Attachment 1

Proposed Technical Specification Changes

Discussion, No Significant Hazards Analysis and
Environmental Impact Statement

The proposed amendment changes the Technical Specification Limiting Condition for Operation (LCO) 3.1.3.5 and Figure 3.1-1 fully withdrawn shutdown rod bank position insertion limit from 228 steps withdrawn to 225 steps withdrawn or higher. The enclosed revision to Technical Specification Basis Section 3/4.1.3 reflects the insertion limit changes.

FIGURE 3.1-1

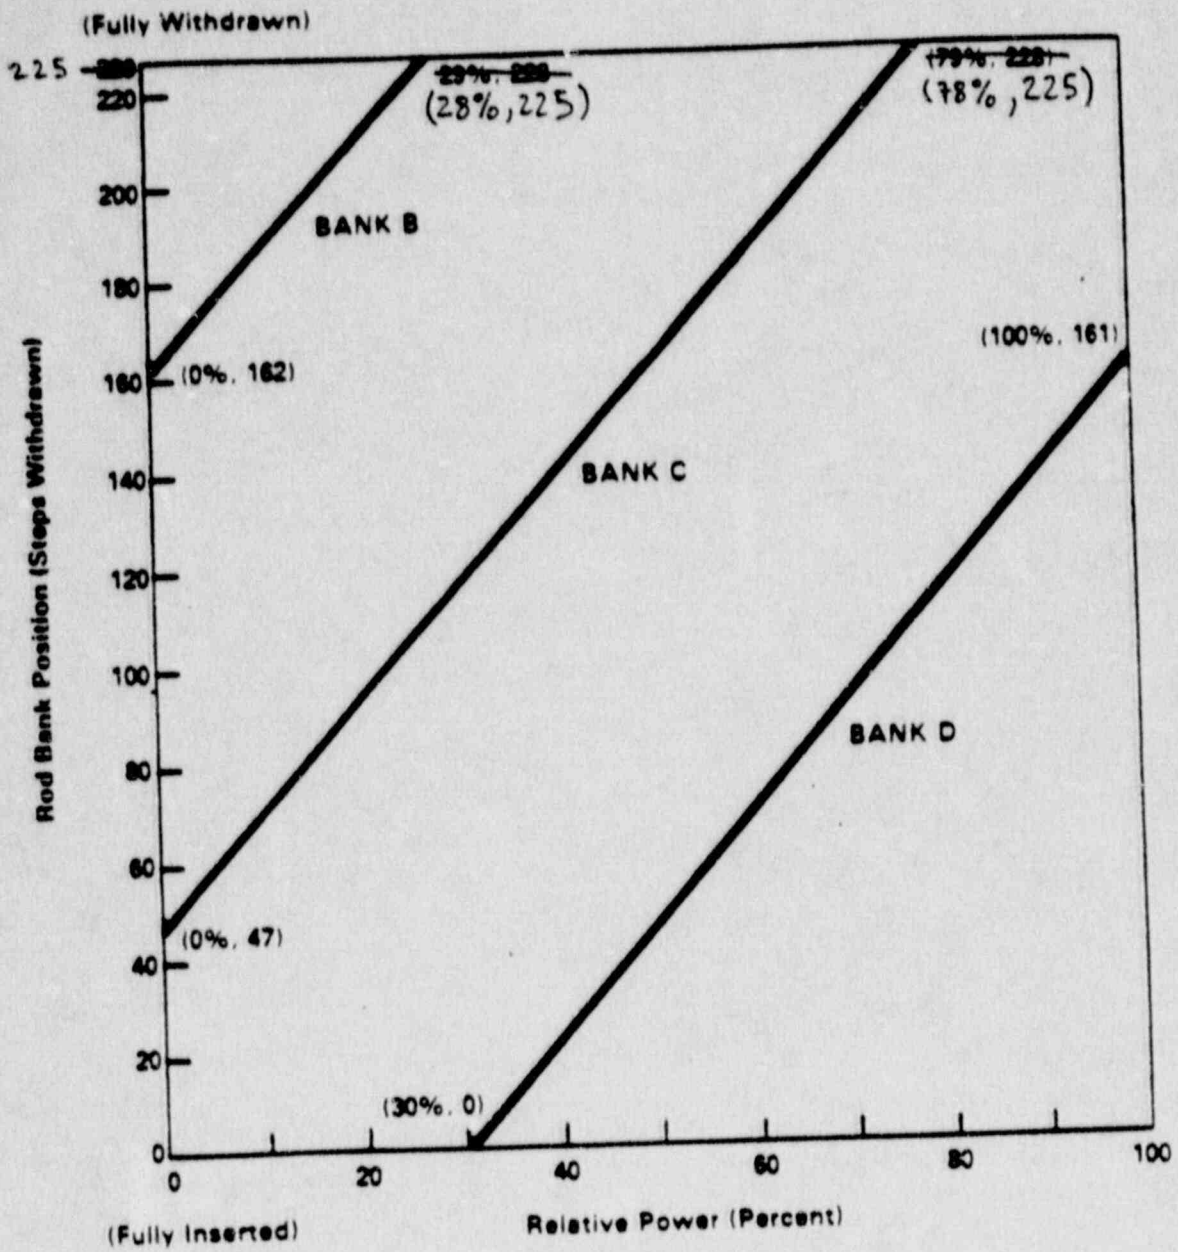
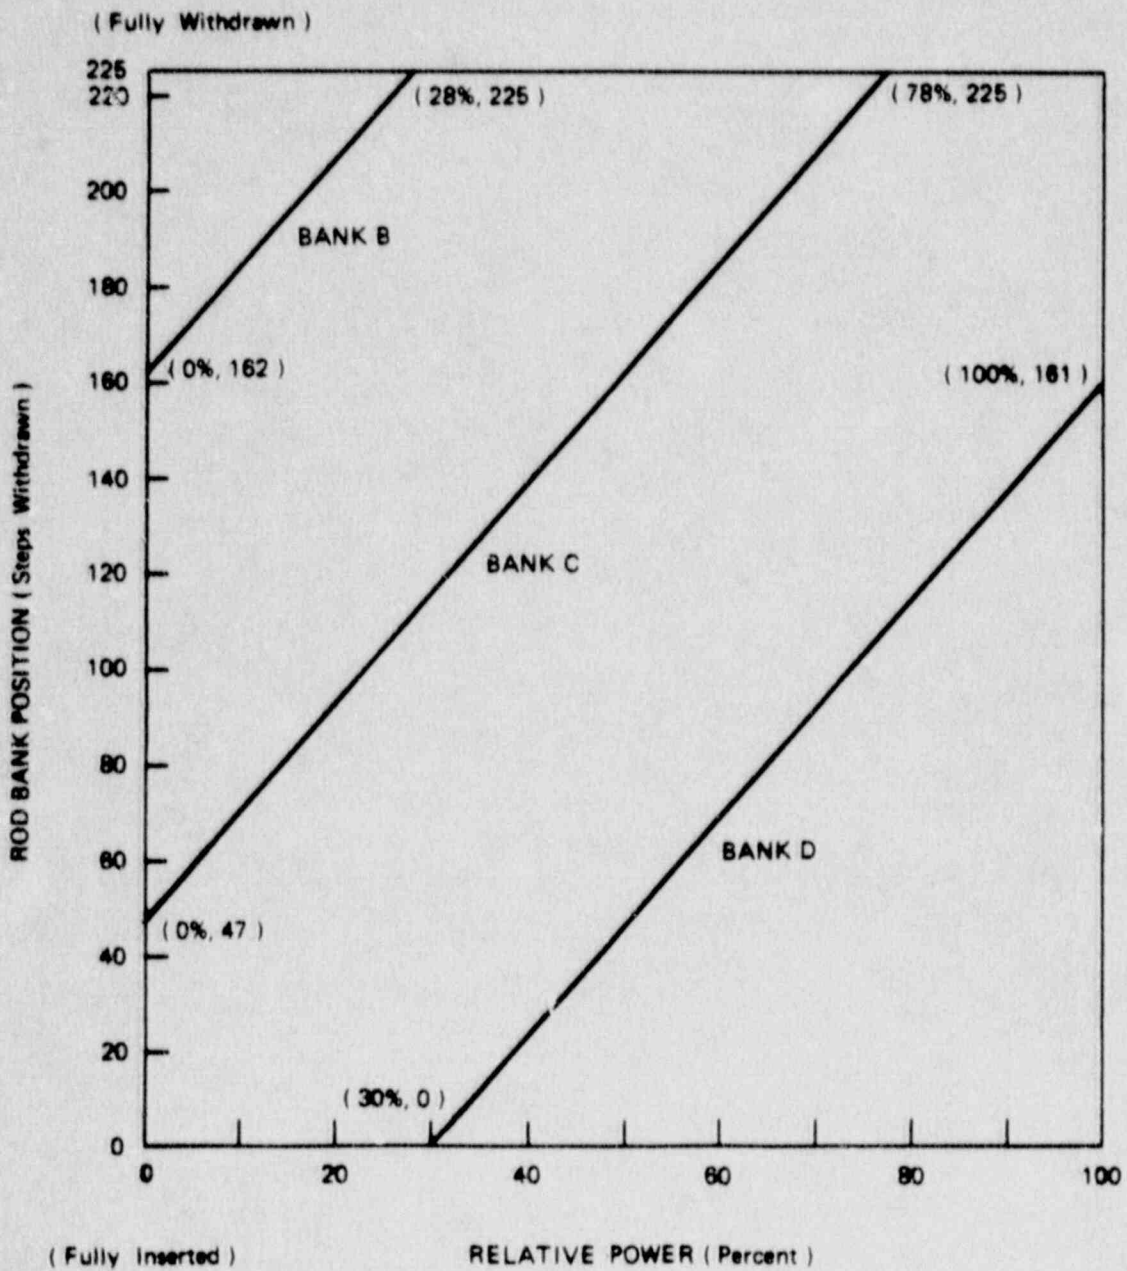
Catawba Technical Specification 3.1.3.6 defines the limiting conditions of RCCA operation such that adequate margin for shutdown capability is maintained at all times. Based on the revised figure 3.1-1, operation of the fully

withdrawn RCCAs at 228 or 230 steps results in an increase in the implied control bank overlap such that the operation of bank B or C at its insertion limit results in a three or four step deviation of the corresponding sequential bank below its insertion limit. The plant operators are alerted to possible violations of these limits through the warning indications provided by the OAC rod alarm monitoring system which contains a low level alarm for each control bank at 10 steps above their respective limits.
